Subject: AIR FROM VENTS NOT COLD WITH AIR CONDITIONER ON	Bulletin No: 07-002/16
	Last Issued: 08/04/2016

2014-15 Mazda3 vehicles (Mexico built) with VINs lower than 3MZBM*****174272 (produced before December 1, 2014)

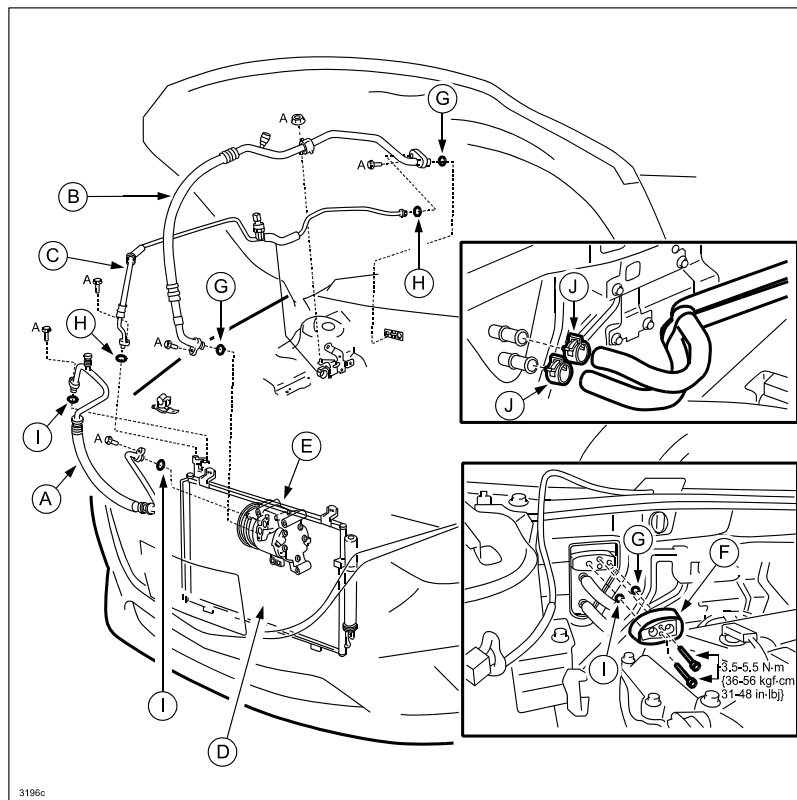
Part Number	Description	Qty.	Notes
BJS7-61-461	Flexible Hose – HIGH	1	(A) in illustration below
BJS7-61-462	Flexible Hose – LOW	1	(B) in illustration below
BJS7-61-46X	Cooler Pipe	1	(C) in illustration below
BJS8-61-480	Condenser	1	(D) in illustration below
KD45-61-450A	Compressor	1	(E) in illustration below
BJS7-61-J10	Evaporator	1	
KF03-61-J14	Expansion Valve	1	(F) in illustration below
BBM4-61-J17	O-Ring	3	(G) in illustration below
GJ6A-61-J19	O-Ring	2	(H) in illustration below
GJ6E-61-J19	O-Ring	3	(I) in illustration below
BP4K-61-242	Hose Clip	2	(J) in illustration below
